MPC8245/MPC8241

Integrated Processor

Device Errata

Rev. 10

**Figure 1. Work Around Chart 1: (DLL_Extend = 1 and Normal Tap Delay)
(DLL Locking Range versus Frequency of Operation)**

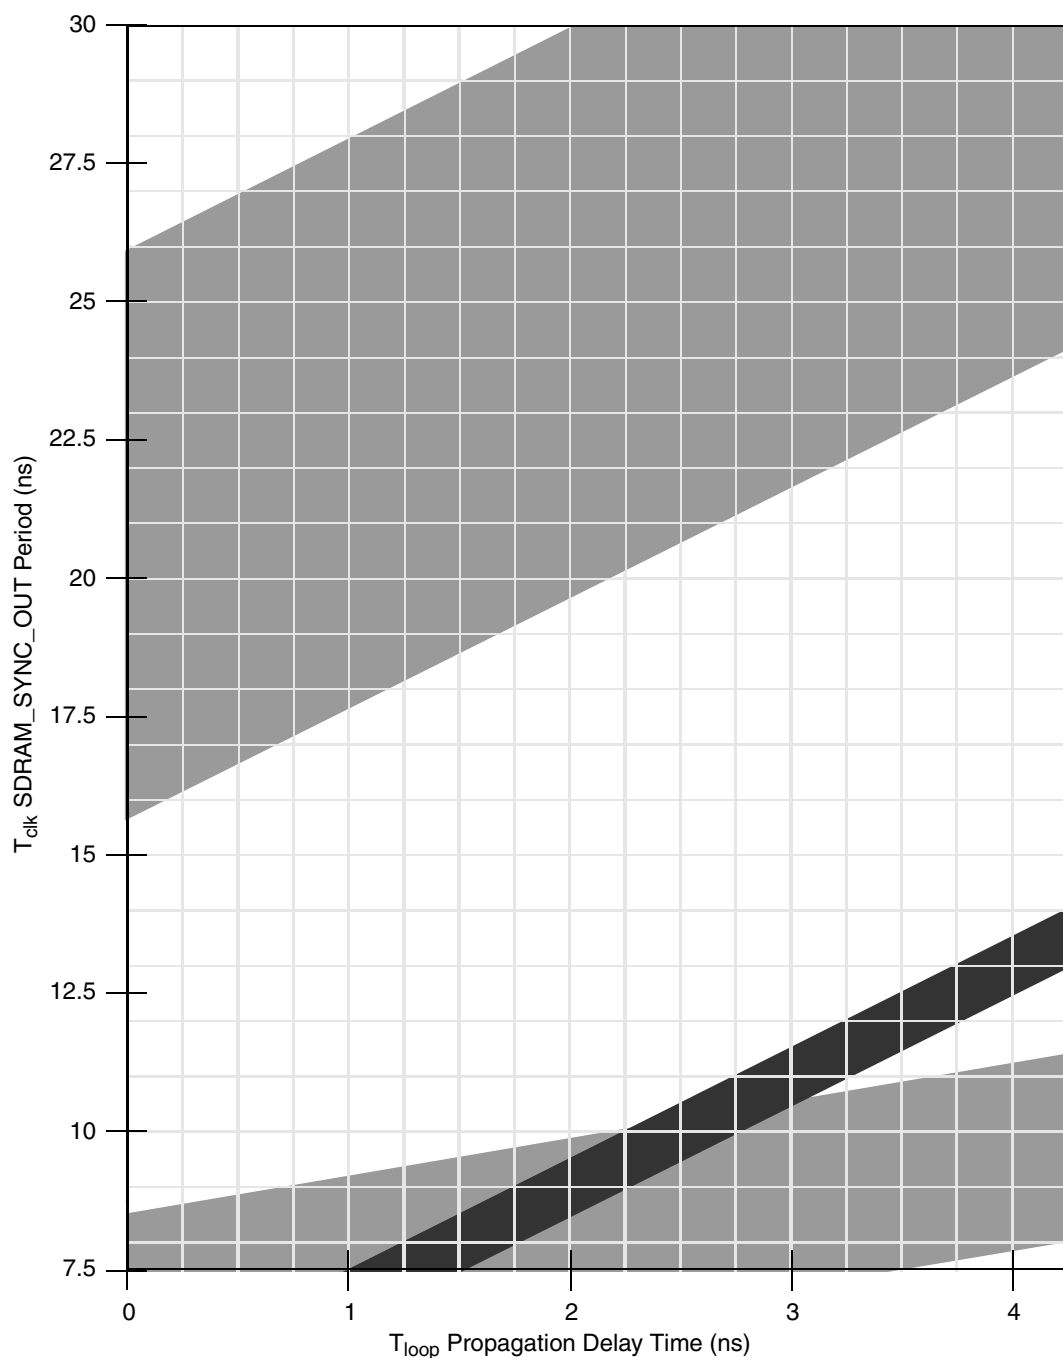
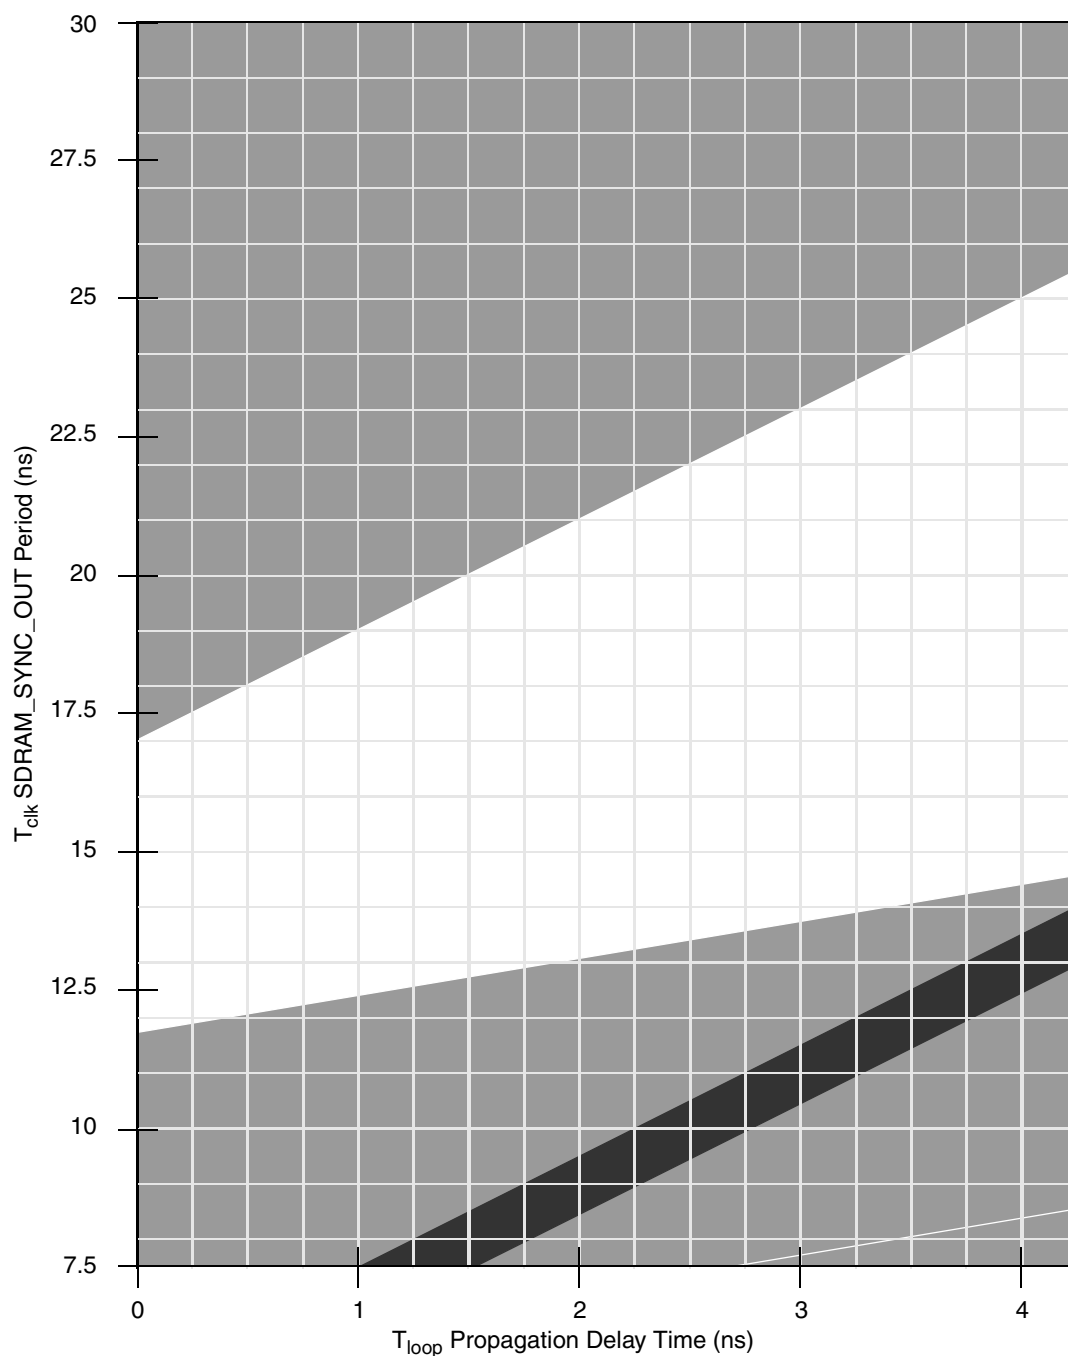
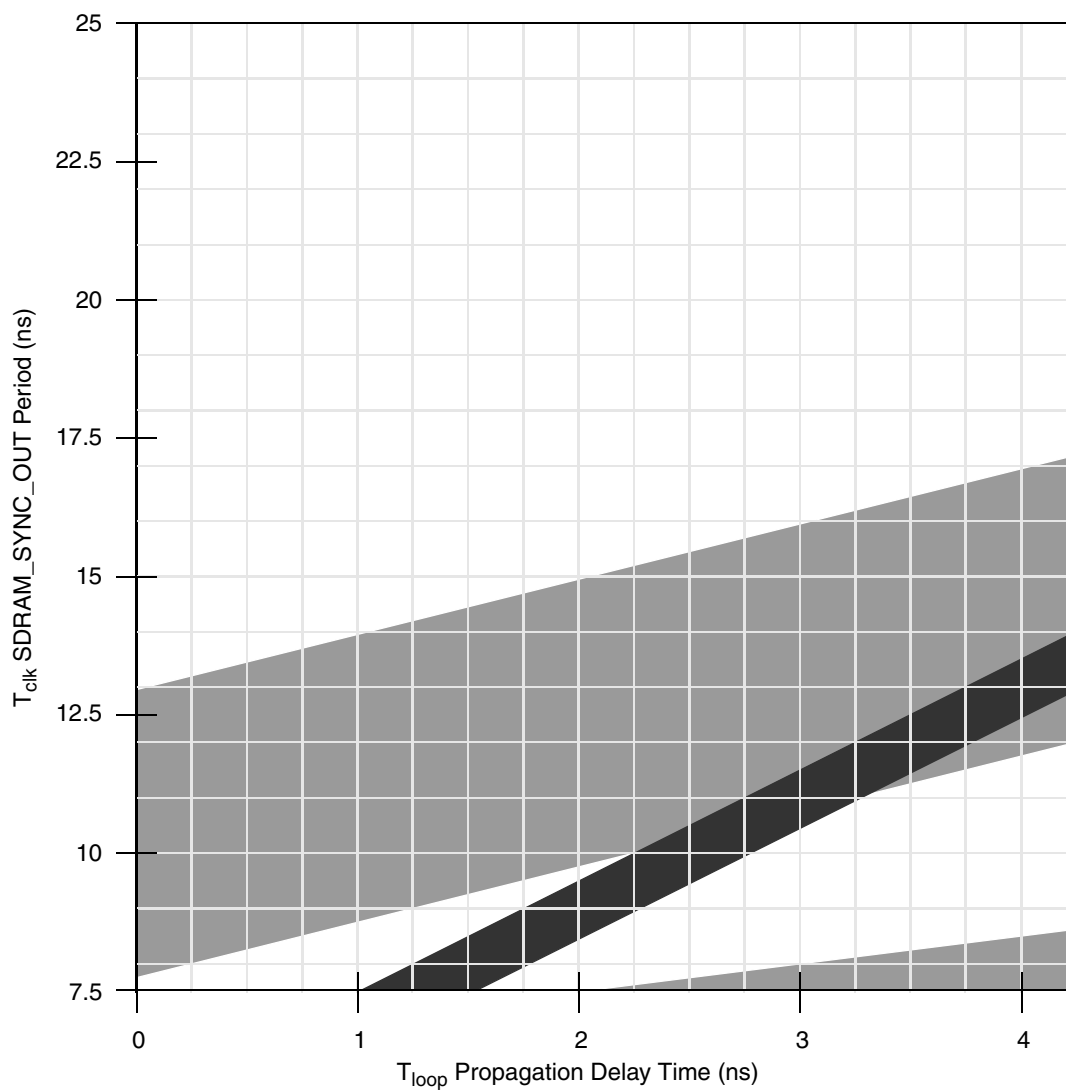
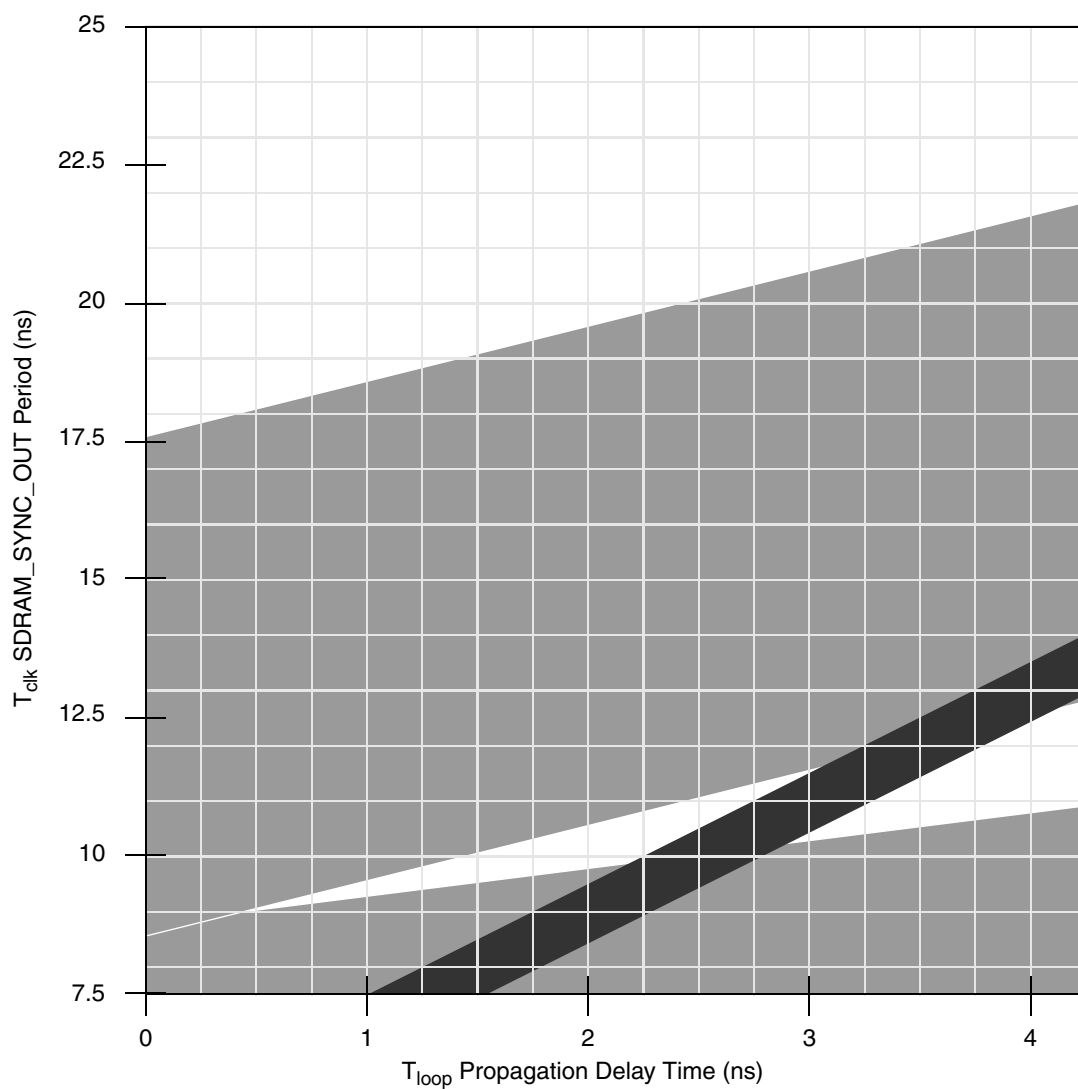
Error No. 12: DLL may not lock under all conditions

The memory interface DLL is sensitive to operating variables that consist of voltage, frequency, temperature, and processing. For a given frequency, an associated feedback loop length range does not function reliably because the DLL intermittently loses lock.

Board designs must avoid certain SDRAM_SYNC_OUT to SDRAM_SYNC_IN feedback loop lengths to prevent intermittent loss of DLL lock.

Using the charts shown in [Figure 1](#) through [Figure 4](#), find the clock speed of the memory interface for the design in question by finding the associated clock period in nanoseconds (ns) on the Y axis. Then use the black band associated with that frequency to index delay times in ns (X axis) that must be avoided when designing the feedback loop for the design. The grey bands indicate valid operating points for different DLL mode settings and represent where the DLL locks. (Do not use white spaces: the DLL does not lock in any non-grey areas.) The black band represents regions; if the DLL is locked in these regions it will be unstable. The width of the black and grey bands take into account temperature, voltage, and processing variations. For any given part, the actual failure region is more narrow than what is shown in [Figure 1](#) through [Figure 4](#). Consult the *MPC8245 Integrated Processor Hardware Specifications* or the *MPC8241 Integrated Processor Hardware Specifications* for more information on DLL locking and the settings. In addition, see Application Note AN2164, *MPC8245/MPC8241 Memory Clock Design Guidelines*.
